UNITED STATES PATENT AND TRADEMARK OFFICE

APPLICATION NO.	FILING DATE	FIRST NAMED INVENTOR	ATTORNEY DOCKET NO.	CONFIRMATION NO.
09/870,418	05/30/2001	Michael K. Blackwell	C01104/70001	8017

Office Action Summary	Application No.	Applicant(s)	
	09/870,418	BLACKWELL ET AL.	
	Examiner	Art Unit	
	Sean P. Shechtman	2125

DETAILED ACTION

FIG. 1

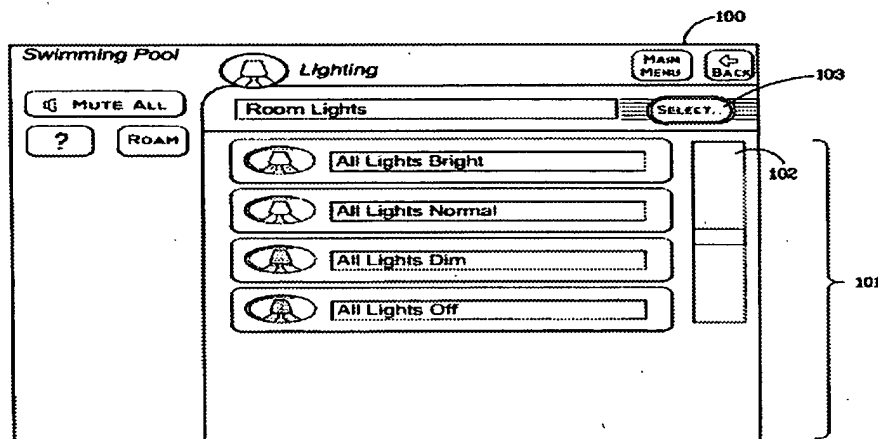
Referring to claims 68 and 84, Pyle teaches a system for preparing and playing back a light sequence, comprising an authoring interface displaying information representative of a plurality of lighting effects (bright and dim); a sequence authoring module to permit a user to select a lighting effect (bright or dim or intensity), a lighting unit to execute the lighting effect (room lights), a start time for the lighting effect, and a stop time for the lighting effect (Col. 5, lines 14-45); and a playback device, coupled to the lighting unit, to playback the light sequence (Col. 9, lines 34-64, especially lines 61-64).

Examiner respectfully notes that the instant specification teaches the term “light sequence” does not require sequential displays. In fact, the term “light sequence” only requires a controlled display with one light. The examiner respectfully submits that the lighting sequence is not required to be functionally related to or used with the authoring interface or sequence authoring interface.

Referring to claim 69, Pyle teaches the system of claim 68, further comprising a lighting set-up module to receive information representative of an arrangement of a plurality of lighting units, and a set-up interface to visually display the arrangement of the plurality of lighting units (See figure above).

Referring to claim 31, Pyle teaches the computer readable medium of claim 30, wherein the lighting program is encoded in a data format having an entry in the lighting program corresponding to every one of the plurality of states for the plurality of lights (See above figure).
